RE: **Item B.6, Regular Council – Land Use Agenda  
Development Application No. 7917-0559-00**

With respect to Item B.6 on the June 10, 2019 Regular Council – Land Use Agenda, Planning recommendation 3(a) on page 3, is to be revised to correct an error related to the proposed setback variance. The variance should be corrected to refer to the minimum side yard on a flanking street setback, not the minimum front yard setback. The recommendation is to be revised as follows:

DEVELOPMENT VARIANCE PERMIT

NO.: 7917-0559-00

SCHEDULE A

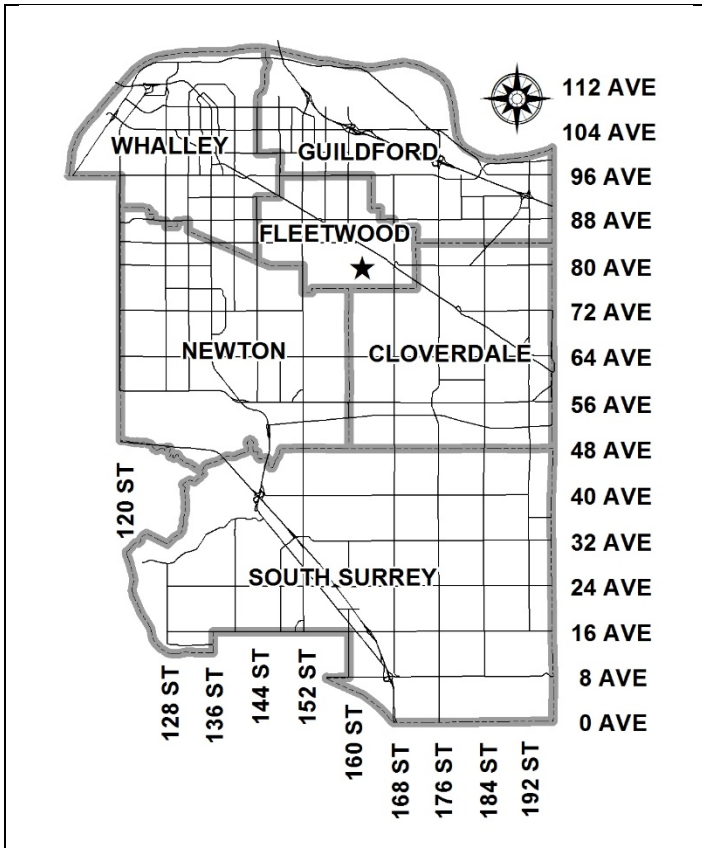
- (a) to reduce the minimum side yard on a flanking street setback of the RA Zone from 7.5 metres (25 ft.) to 4.1 metres (13 ft.) for an existing accessory building on proposed Lot 27.

Reduce the minimum side yard on a flanking street setback of the RA Zone from 7.5 metres to 4.1 metres for an existing accessory building on proposed Lot 27.
